City of Phoenix Office of the City Engineer Design and Construction Procurement

HAPPY VALLEY ROAD: 67TH AVENUE TO 35TH AVENUE ROADWAY IMPROVEMENTS DESIGN-BID-BUILD

> PROJECT NO. ST85100437 FEDERAL AID NO. PHX-0(363)D ADOT TRACS NO. T0239 01C

ADDENDUM NO. 2

TABLE OF CONTENTS

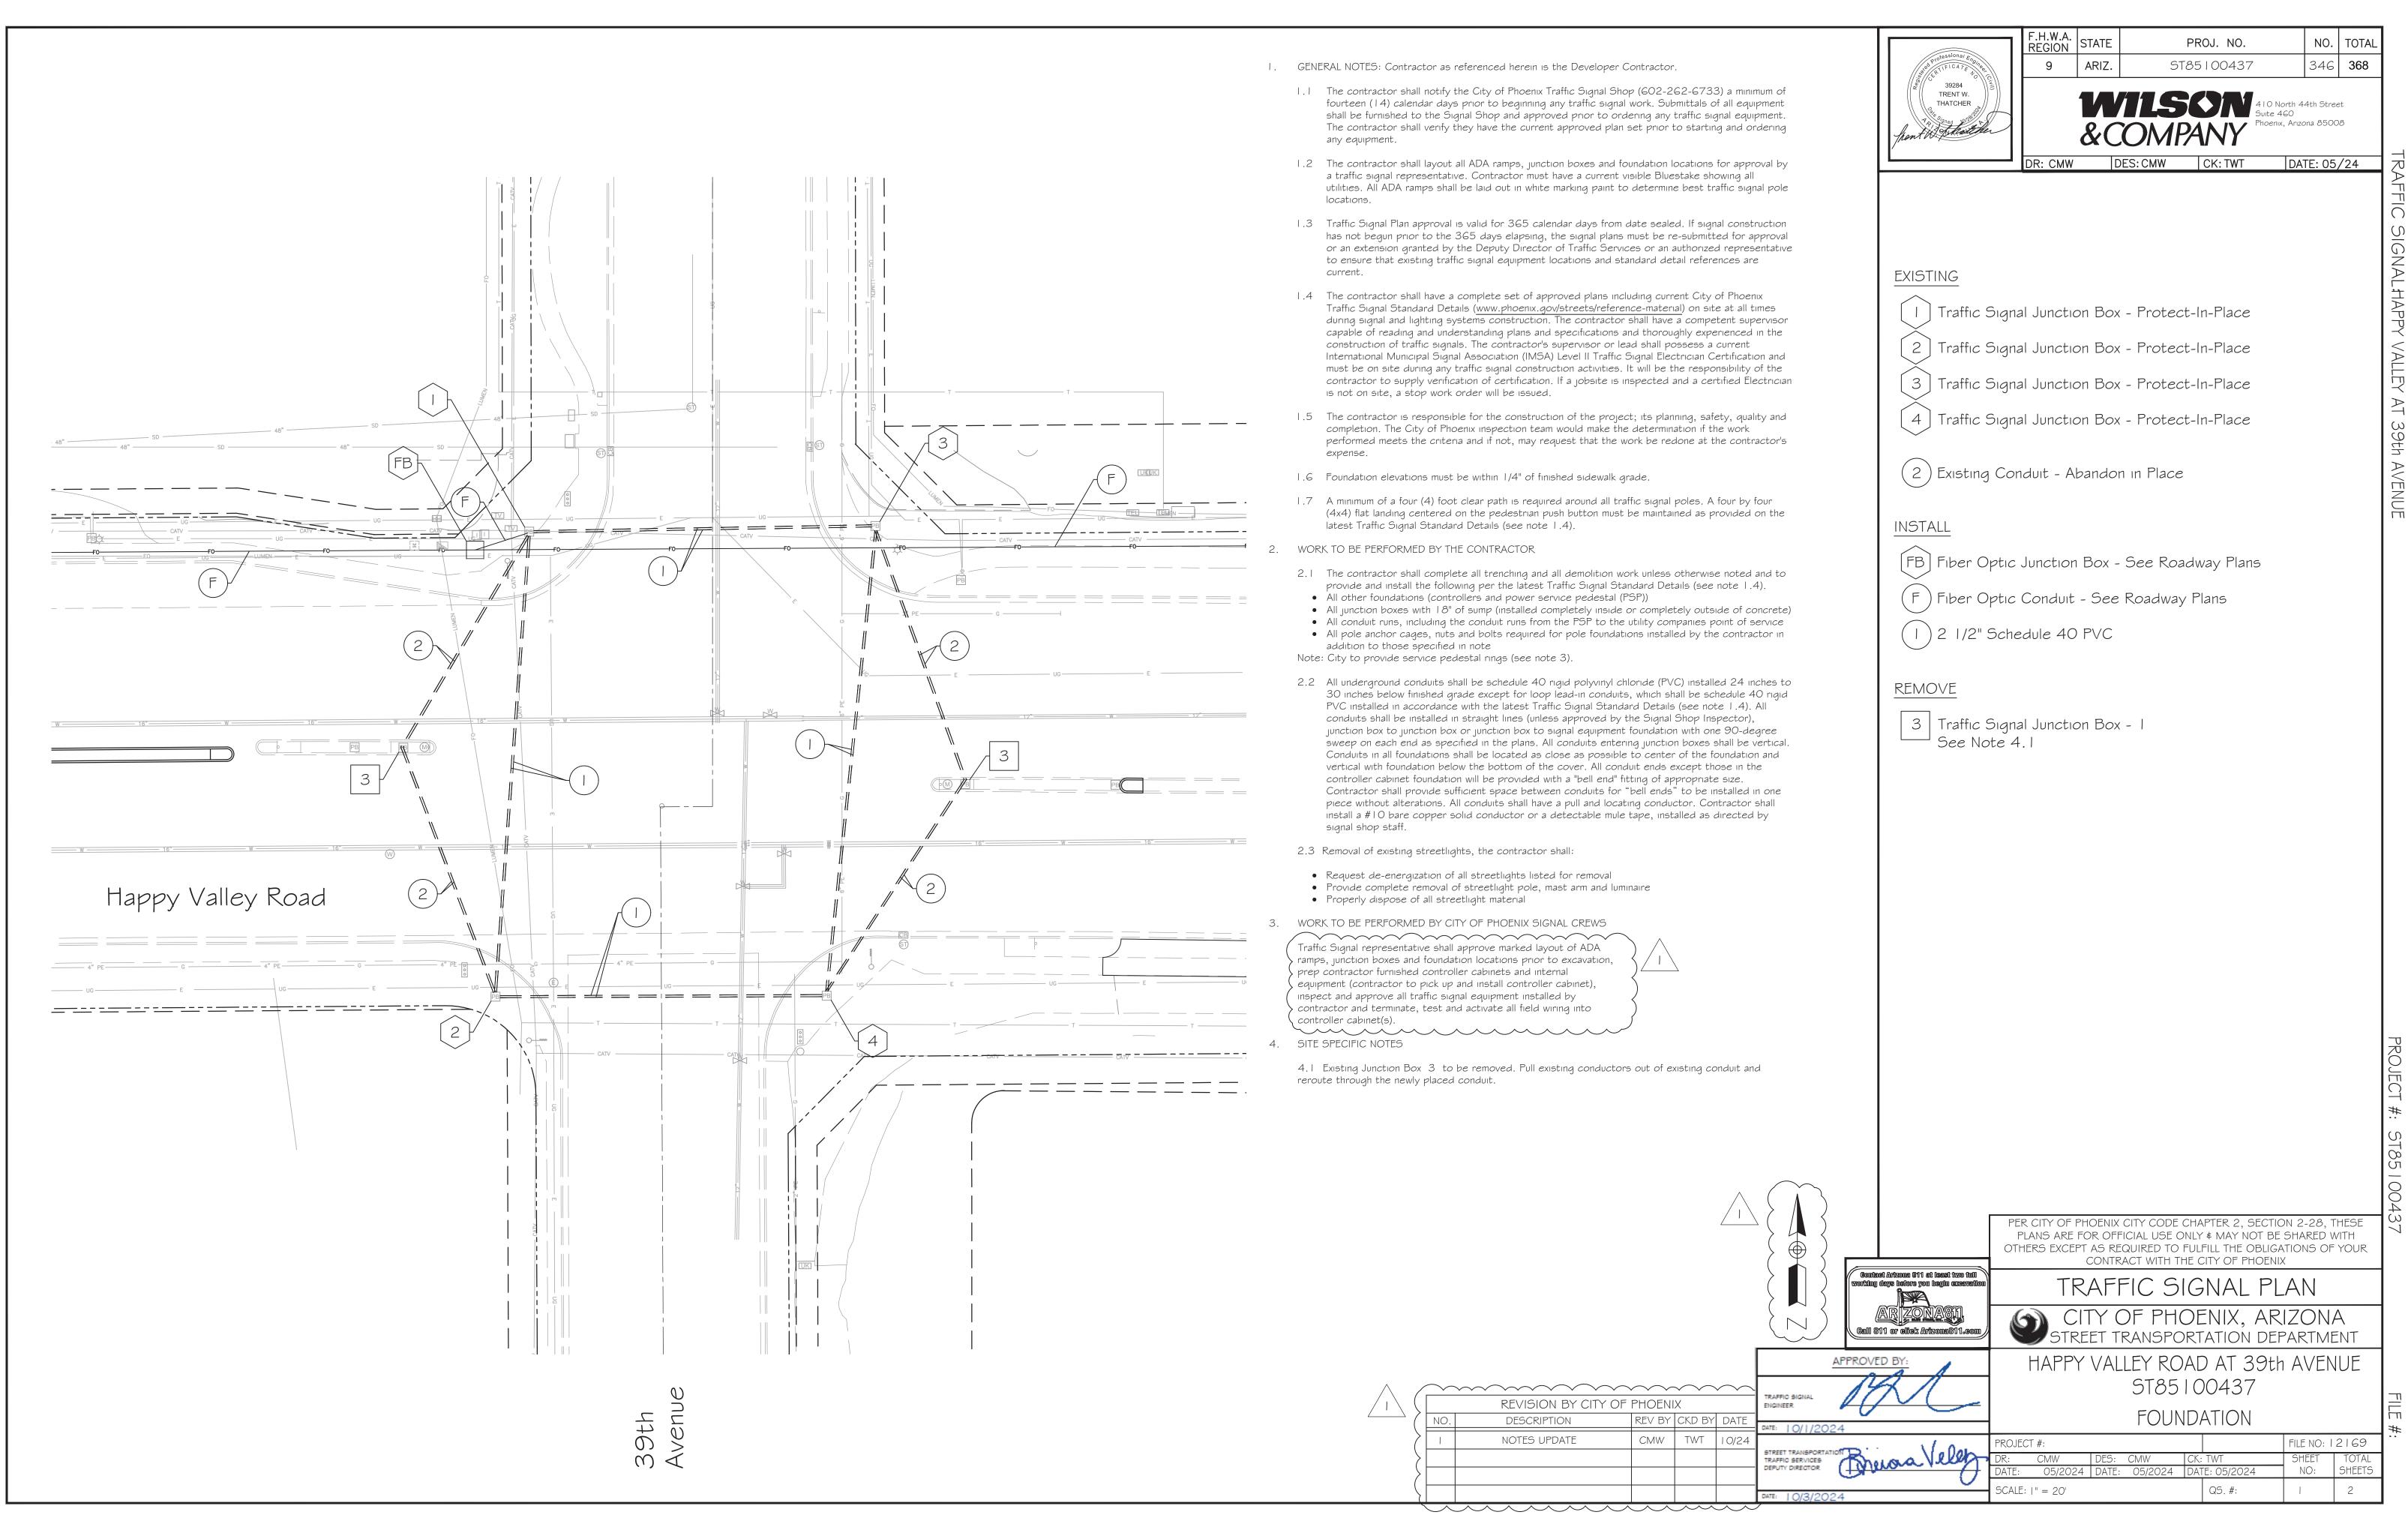
- Q21. Clarify what electrical materials are being provided and installed by the City. The special provisions, pay items and the traffic signal plans and details (specifically note 3) contradict each other.
- A21. Plans: Note 3 on Wilson & Company's traffic signal sheets reflects a non-federal aid note to contractors. See attached revised plans. Replace Note 3 on sheets 320, 328, 336, 344, and 346 with the following:
 - 3. WORK TO BE PERFORMED BY CITY OF PHOENIX SIGNAL CREWS
 Traffic Signal representative shall approve marked layout of ADA ramps, junction boxes
 and foundation locations prior to excavation, prep contractor furnished controller
 cabinets and internal equipment (contractor to pick up and install controller cabinet),
 inspect and approve all traffic signal equipment installed by contractor and terminate,
 test, and activate all field wiring into controller cabinet(s).
